**ALBERTA TRANSPORTATION
SPRINGBANK OFF-STREAM RESERVOIR
PROJECT
Response to NRCB and AEP
Supplemental Information Request 2,
dated November 18, 2019**

Prepared for:
Alberta Transportation

Prepared by:
Stantec Consulting Ltd.

April 2020

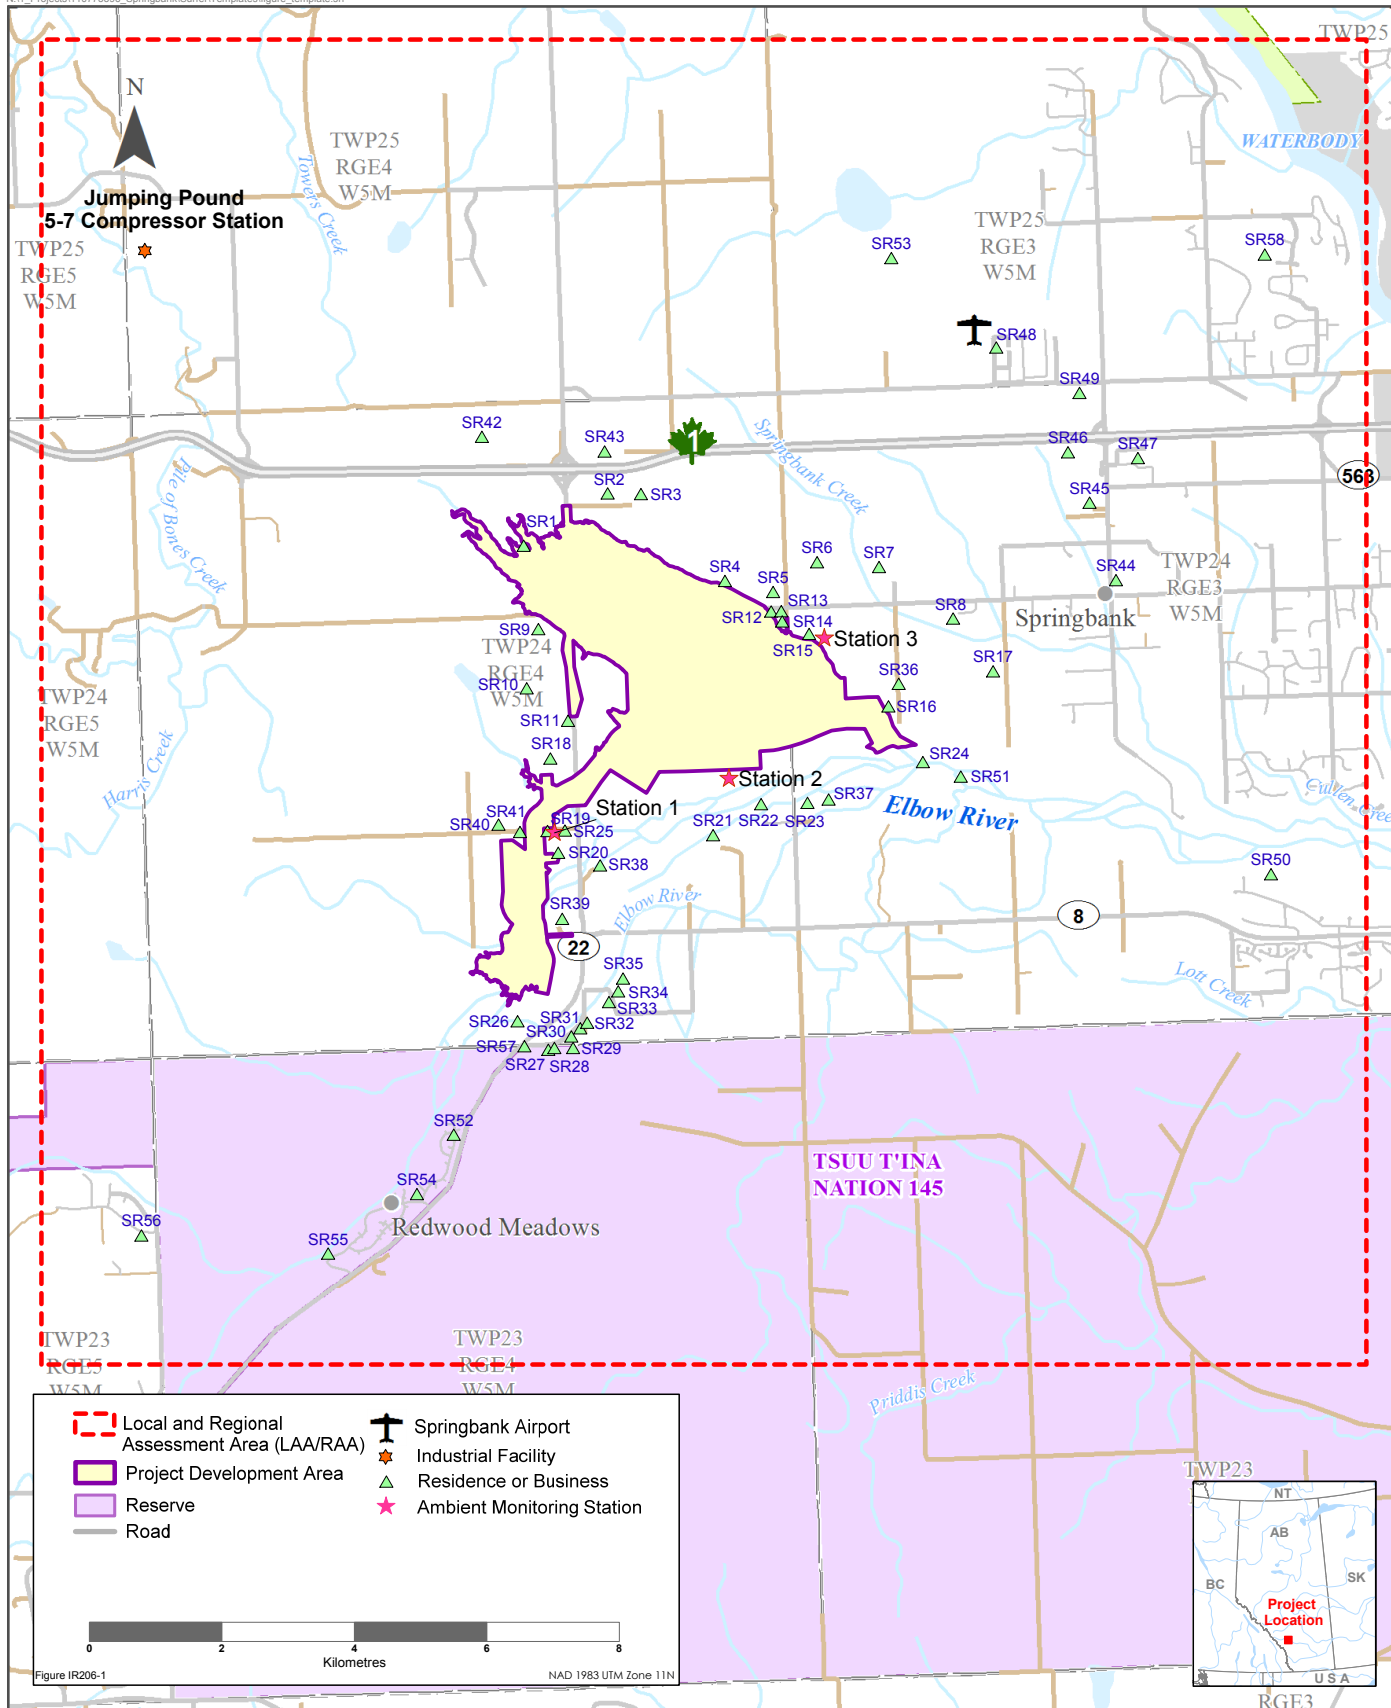
Alberta Transport states During construction, activities between the diversion channel and the dam, there will be 24-hour continuous wind and air quality monitoring for PM_{2.5} and TSP at Stations 1 and 2 along the haul road and at Station 3 near the borrow source area as illustrated on Figure IR206-1. The proposed locations of the air quality monitoring stations were selected based on modelling results.

a. The proposed monitoring program has been adjusted to provide monitoring data representative of the SR41 and SR19 locations. The proposed monitoring program is explained in detail below.

Three ambient air quality monitoring stations are proposed outside the PDA, as described in Alberta Transportation's response to Round 1 AEP IR206 and shown in Figure IR206-1. The ambient air monitoring will include monitoring of PM_{2.5} and TSP. The locations of the air quality monitoring stations are based on the highest expected fugitive dust emissions generated by the haul trucks transporting earth material from the diversion channel to the dam, and the spatial distribution of maximum predicted PM_{2.5} and TSP concentrations.

Two monitoring locations (Station 1 and Station 2) are proposed between the haul road from the diversion channel excavation work to the dam construction site and nearby residences, and one monitoring location (Station 3) is proposed between the borrow source area and nearby residences (see Alberta Transportation's response to Round 1 AEP IR206, Figure IR206-1).
